1 2		ATTACHMENT NO. 3	
3		ATTACHMENT NO. 3	
4		RW No. 1, January 2011	
5			
6			
7	National Committee on Uniform Traffic Control Devices		
8 9	RWSTC RECOMMENDATION FOLLOWING SPONSOR COMMENTS		
10	TECHNICAL COMMITTEE:	Regulatory/Warning Signs	
11	TONIC	T E IC	
12 13	TOPIC:	Lane End Signs	
13	DATE OF ACTION: (TASK FORCE): 1	May 25, 2010	
15	RWSTC APPROVAL DATE:	June 30, 2010	
16		ONSOR COMMENTS: January 19, 2011	
17	TRANSMITTAL TO SPONSORS DATE: October 28, 2010		
18	<b>COUNCIL APPROVAL DATE: 1-20-11</b>	,	
19			
20	ORIGIN OF REQUEST:	<b>RWSTC Review of the 2009 MUTCD</b>	
21			
22	AFFECTED PORTIONS OF MUTCD:	Section 2C.42, Figure 3B-14	
23	CYTMANAADSV		
24 25	SUMMARY: The 2000 MUTCD revised Section 2C	42 Lana Enda Signa (W/4 2 W/0 1 W/0 2)	
26	from the 2003 MUTCD and the 2007 NPA.	42 Lane Ends Signs (W4-2, W9-1, W9-2)	
27	from the 2003 WOTED and the 2007 NFA.	Some meonsistencies were identified	
28	The requirement in the second Guidance	ee statement (paragraph 03) of Section 2C.42,

## **RECOMMENDATION: Amend Section 2C.42 and Figure 3B.14**

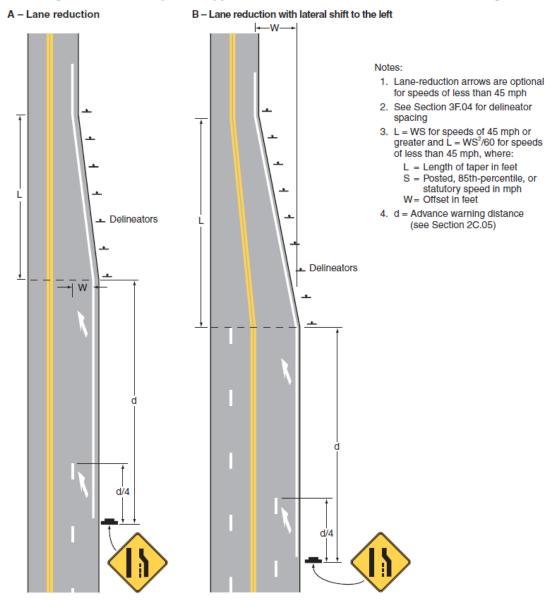
29	to place the RIGHT (LEFT) LANE ENDS (W9-1) sign adjacent to the Lane Reduction		
30	pavement marking arrow may not agree with the placement of the "Lane Ends" sign		
31	(W4-2) shown on Figure 3B-14. There should be consistency between Section 2C.42 and		
32	Figure 3B-14. Figure 3B-14 is included for reference at the end of this document.		
33			
34	The reference to a "Lane Ends word sig		
35	(paragraph 06) in Section 2C.42 is confusing. It is not clear whether reference is being		
36	made to a LANE ENDS MERGE LEFT (RIGHT) sign (W9-2), a RIGHT (LEFT) LANE		
37	ENDS (W9-1) sign or a simple LANE ENDS word sign that is not shown in the		
38	MUTCD. The statement needs to be clarific	ed.	
39 40	The first Guidenee statement (naregreen	h (1) of Section 2C 42, allows the use of	
41	The first Guidance statement (paragraph 01) of Section 2C.42, allows the use of either the LANE ENDS MERGE LEFT (RIGHT) sign (W9-2), or the "Lane Ends" sign

Figure 3B-14 shows a "Lane Ends" sign (W4-2) a distance "d" from the beginning of the taper. The first Guidance statement (paragraph 01) in Section 2C.42 says that the LANE ENDS MERGE LEFT (RIGHT) sign (W9-2) may be used instead of the "Lane Ends" sign (W4-2). Figure 3B-14 should be revised to show the optional use of both signs.

Neither Section 3B.09 "Lane Reduction Transition Markings" nor Section 3B.20 "Pavement Word, Symbol and Arrow Markings" give any guidance to how many lane reduction arrow pavement markings to use. If the requirements of the second Guidance statement are followed, the sign and arrows would be off of the drawing and off of the page.

The Marking Committee should review the situation and, if necessary, revise Figure 3B-14.
